## PLAN COMMISSION

October 23, 2018  
6:00 P.M.

## PLAN COMMISSION REPORT

Proposal: Plan Review - Hospital

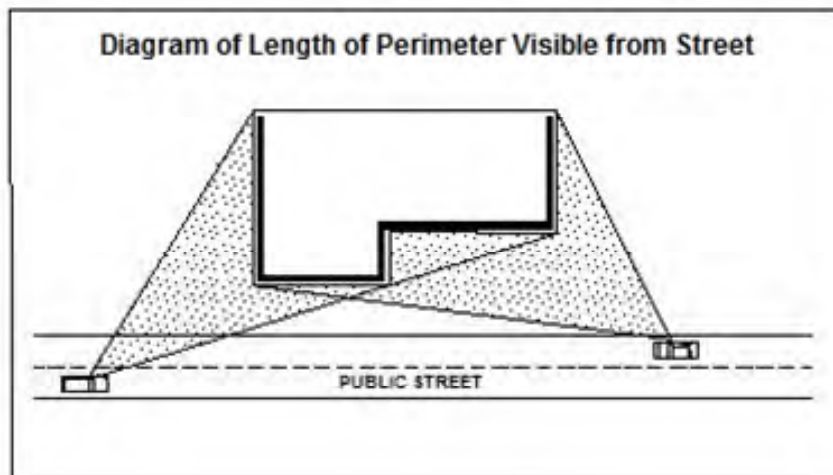
Access to the property is restricted to a proposed shared easement to the north of the parcel. No access is allowed directly to the parcel from S. 13<sup>th</sup> St. or W. Drexel Ave.; however, as the shared access through the easement will require a direct access from S. 13<sup>th</sup> St., approval from Milwaukee County will be required. Copies of all access approvals are required to be provided to the City prior to submission of building permit applications per the suggested conditions of approval above.

Minimum parking requirements are calculated at two (2) stalls for every three (3) patient beds, plus one (1) space per staff doctor, plus one (1) stall for each employee onsite during the largest shift. The total number of doctors is forthcoming; however, as previously mentioned, ten (10) employees are anticipated at peak shift and fifteen (15) patient beds will be provided. Plans show a total of 35 parking stalls on the east and west sides of the building. With the above information, a minimum of 21 parking stalls would be required (excluding the total number of doctors). Therefore, the minimum number of parking stalls in the proposed plans appears to be exceeded.

# Elevations

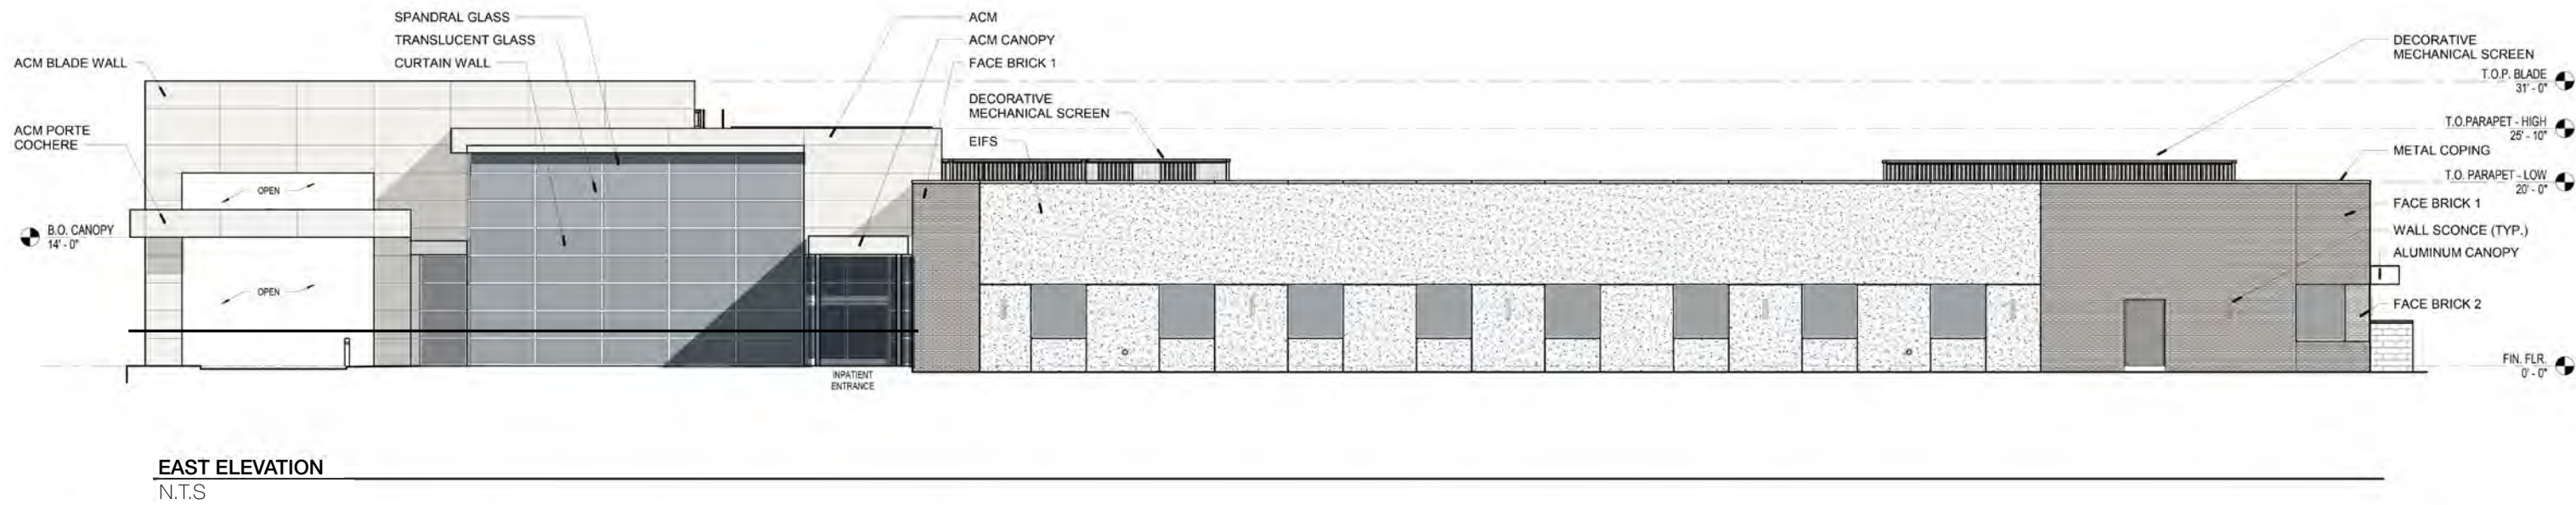
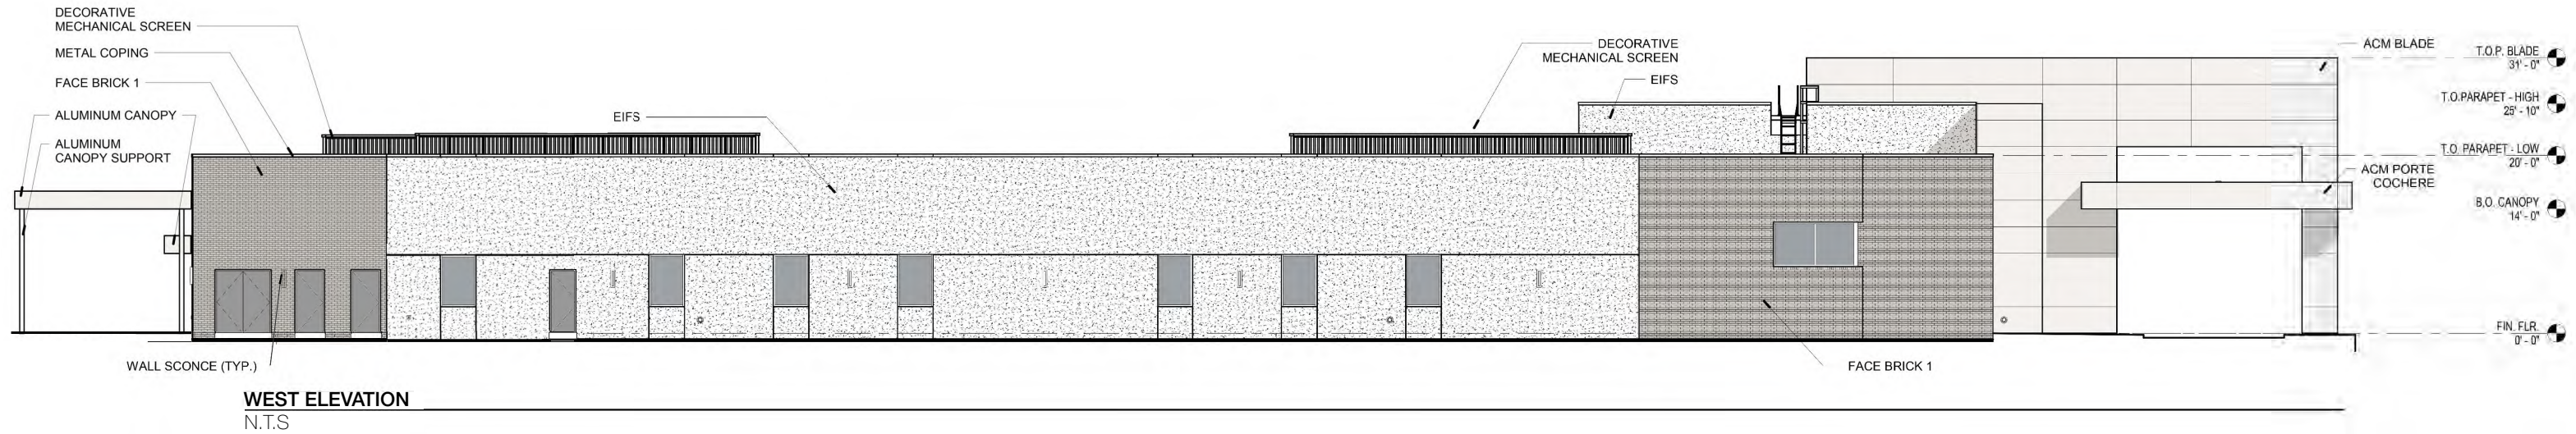
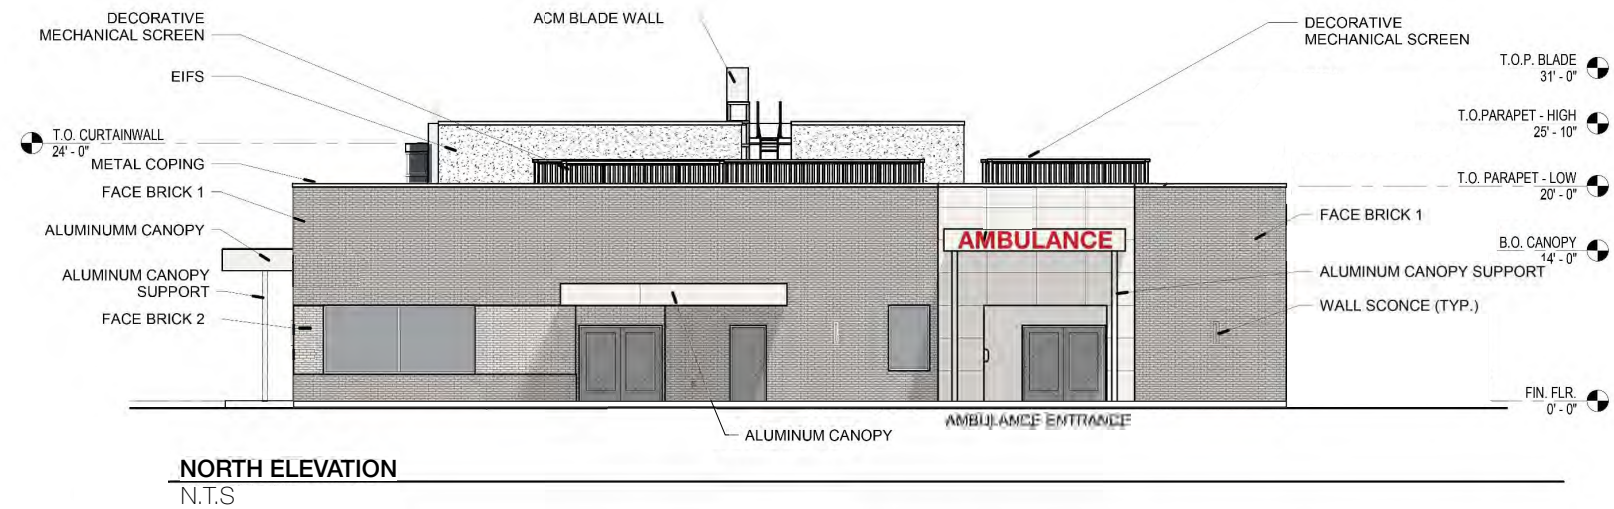
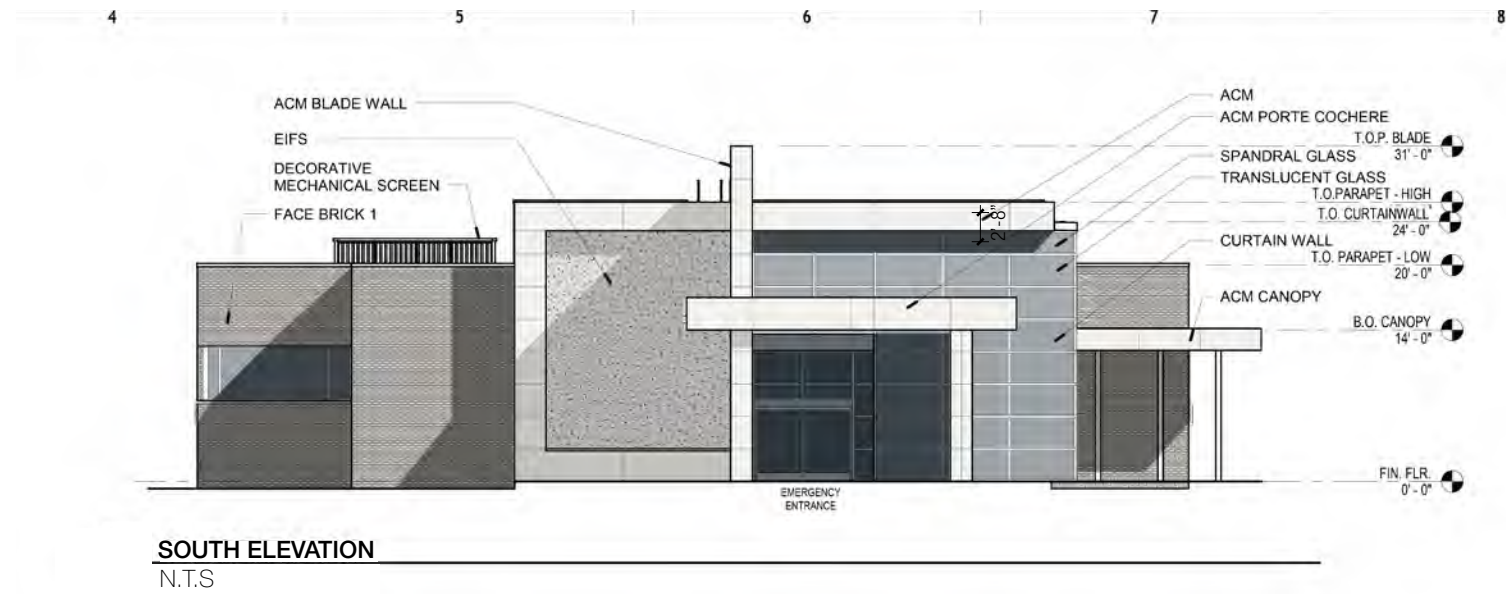
The building is proposed to be constructed with 2 types of face brick (must meet minimum 4-inch requirement per Code), EIFS, architectural metal panels, and glass (spandrel and translucent windows and a curtain wall) as the primary exterior building materials on all elevations. Decorative metal screens (flat rib panels in gray) for rooftop mechanical units and aluminum canopies over entrances are also proposed. A

It is difficult to determine which windows are included in the spandrel label on the submitted plans. Spandrel windows must be clearly labeled on the plans. Architectural metal panels are not listed as approved primary building materials in the Municipal Code. This will require a  $\frac{3}{4}$  majority approval of the Plan Commission. EIFS is also not allowed as an exterior building material unless used as an accent comprising no more than 25% of the visible perimeter. Additionally, Section 17.1009(a)(2)(ii) states: "The façade of a manufacturing, commercial, office, institutional, or park building shall be finished with an aesthetically pleasing material. A minimum of seventy-five (75) percent of the visible perimeter (see diagram) shall be finished with an acceptable glass, brick or decorative masonry material."

5. That plans are revised to meet Code requirements for exterior building materials.
6. That all mechanical equipment, transformers, and utility boxes (ground, building, and rooftop) are screened from view.

# Dumpster Enclosure and Generator Elevations

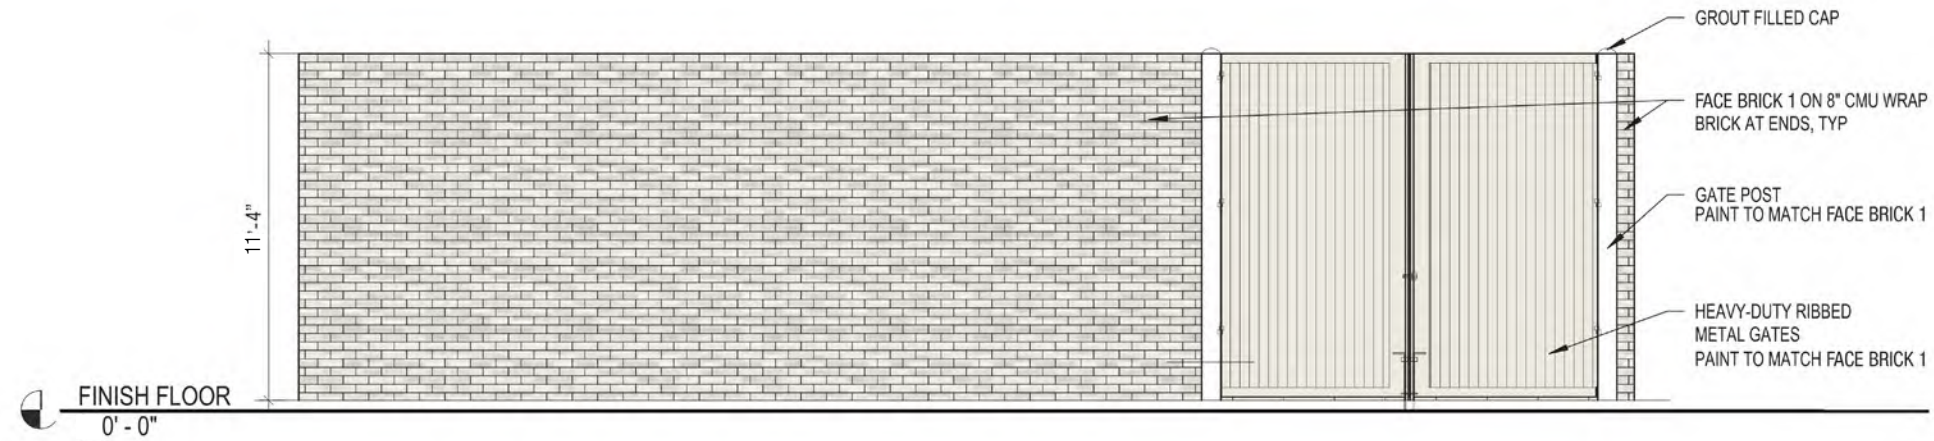
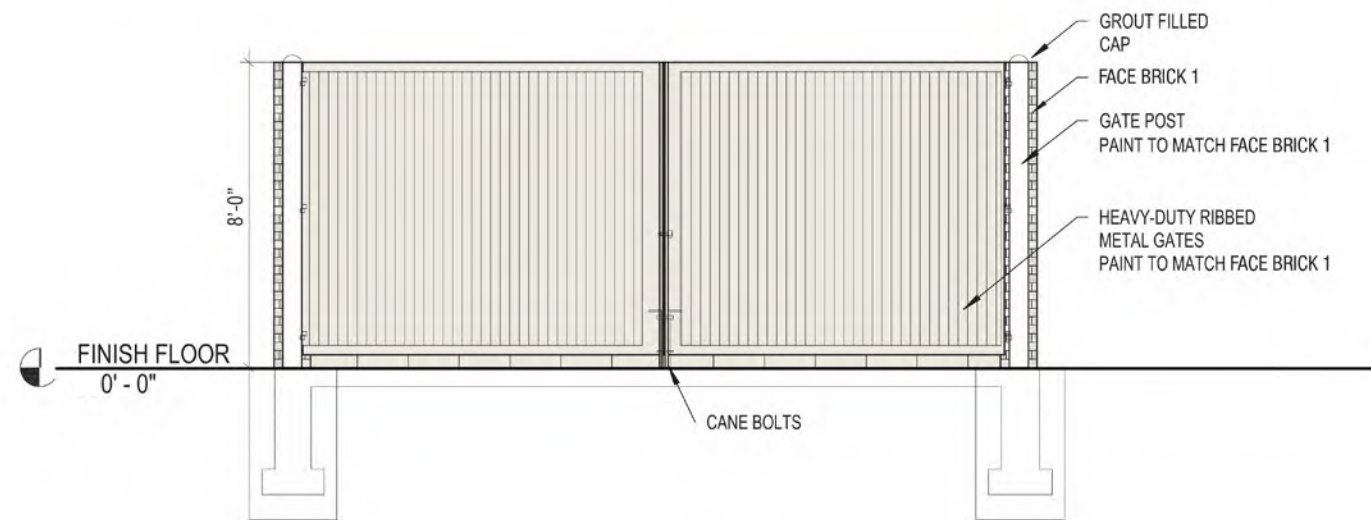
One (1) trash receptacle enclosure has been identified on the northeast side of the building, to be constructed with the same face brick to match the building and ribbed metal gates. Per Code, trash enclosures must be located outside of street and front yards. Staff is currently working with the Applicant's consultant on proper siting of the enclosure, which may require only slight modification.
